ORDER NO.	1
DATE	1/17/2024
STATE	CA
COUNTY	Fresno

## CONTRACT CHANGE ORDER

**CONTRACT FOR**                      LIONS PARK RECHARGE PROJECT

**OWNER**                                      CITY OF KERMAN

**OPTION A - EXHIBIT**  
 1-11-2024

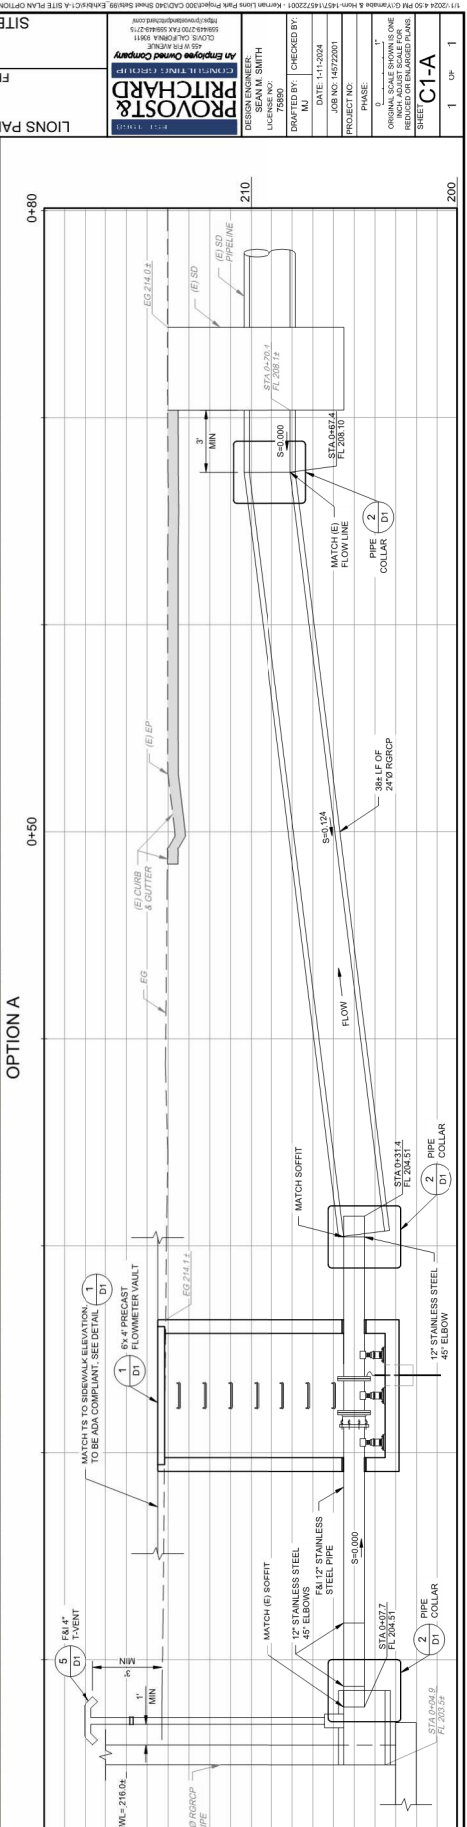
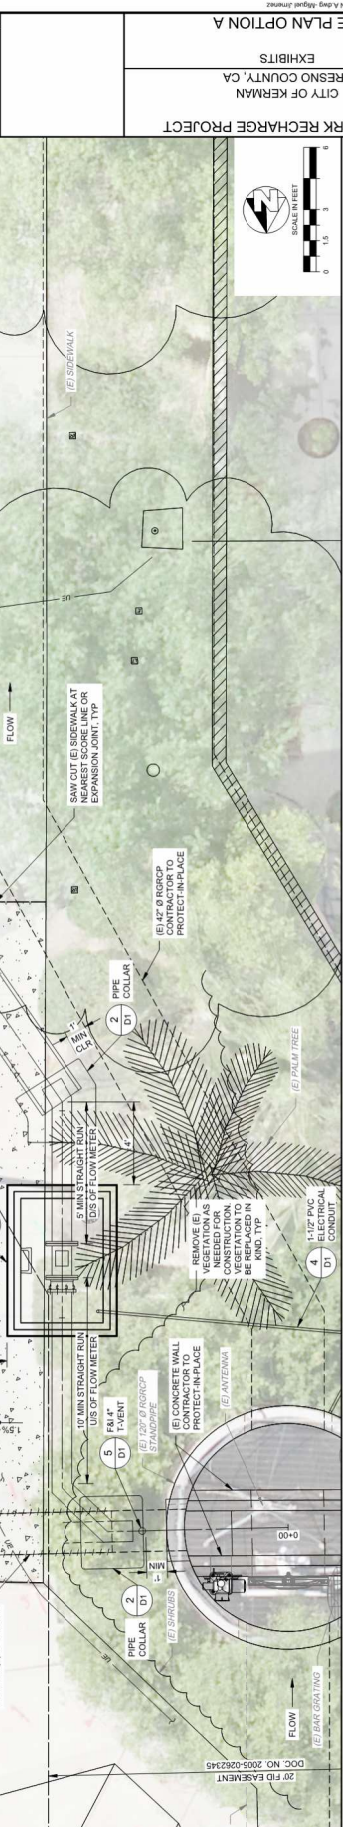
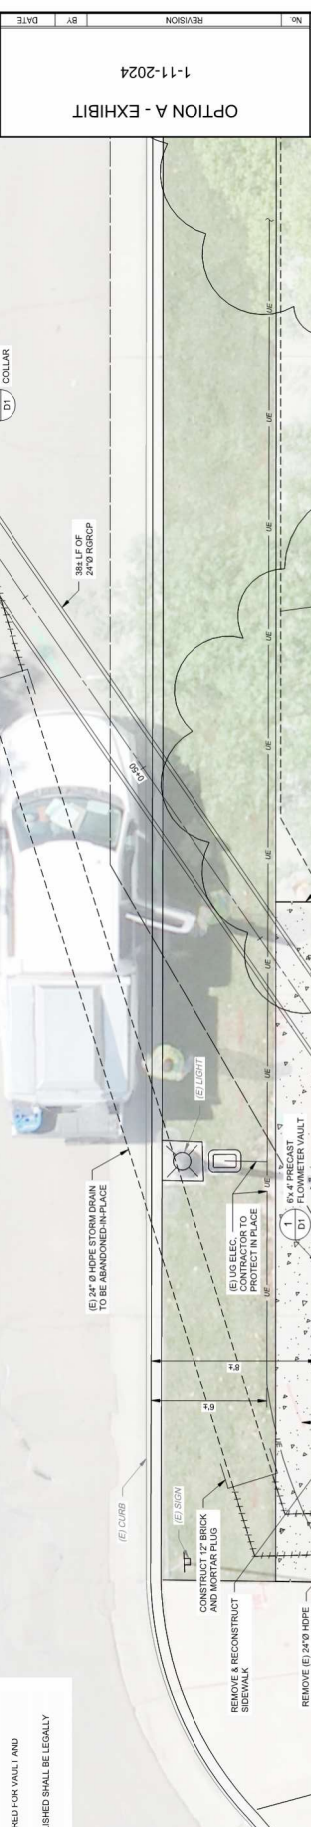
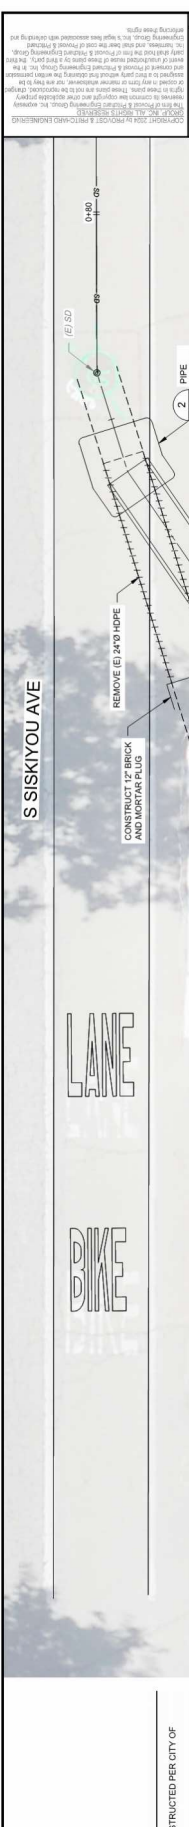
Item 1.1 Construct improvements per the SITE PLAN OPTION A Exhibit attached dated 1-11-2024. Contract working days shall be extended due to the unforeseen conditions. The Contractor shall perform the extra work on Time & Material not to exceed the estimated amount of \$127,553.36

**1.1 Plan Revision Dated 1-11-2024 Vault and Storm Drain layout revision to due unforeseen conditions: PG&E conflict and As-Built Plan discrepancy**

The contractor shall construct the improvements per the exhibit attached and shall comply with the City of Kerman Standard Specifications. All work within the Fresno Irrigation District easement shall comply with the FID Standard Specification and standard plans. The contractor shall perform the extra work on time and material with the condition to not exceed the estimate amount of \$127,553.36 per the estimate attached. All Time and material documentation shall be submitted for review and approval.
